## Index 700-010 Single Column Ground Signs

FY 2025-26 STANDARD PLANS

SINGLE COLUMN GROUND SIGNS

WIND BEAM CONNECTION FOR ESU FLIP SIGNS

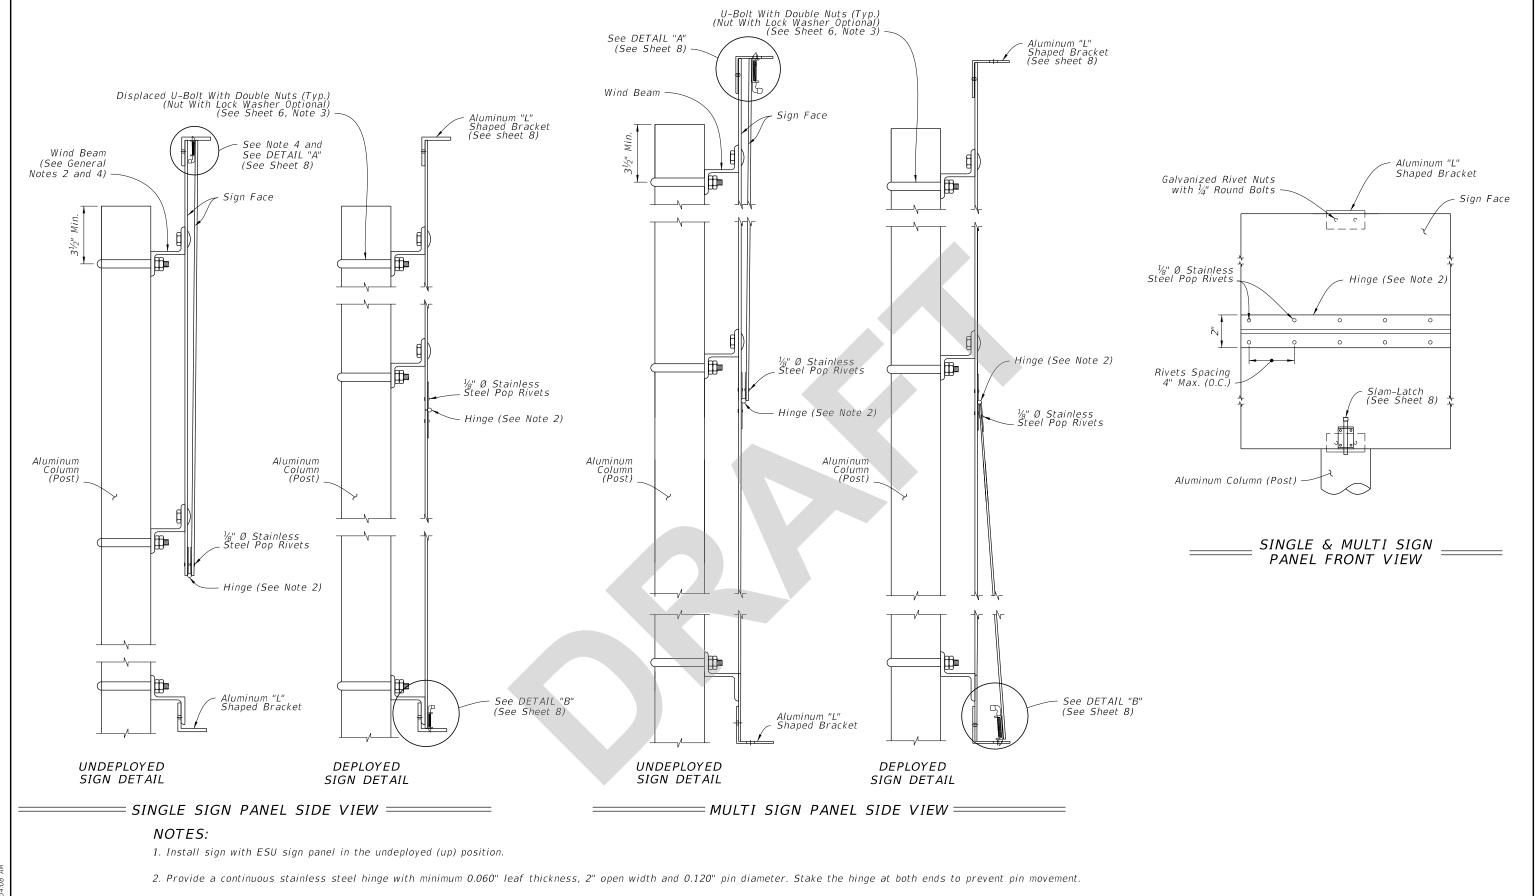
**COMMENT:** Is the sheeting placed above/over the hinge, or should a note address splitting the sheeting where the hinge is located? The size of the closed/undeployed signs varies from 2'-6" (FTP 47-06) to 5' (FTP 66-21). What is the size of the ESU message? Where are the details located?

**RESPONSE:** The sheeting is to be applied before the hinge. There are a few signs that have 3 rows of text that will be affected but there have been no issues with the districts that have already implemented the flip signs. The signs that have 4 rows of text will not be affected by the hinge. The intent was to have the message from the signs listed in note 5 used. They would need to be scaled to the 5' height ESU sign size. They are located on ESU concept plans and the district standard operating plans (SOP) the size for all permanent signs is 5' by 4'.

CHANGE MADE TO INDEX: Yes, updated Note 5 to clarify scaling the size
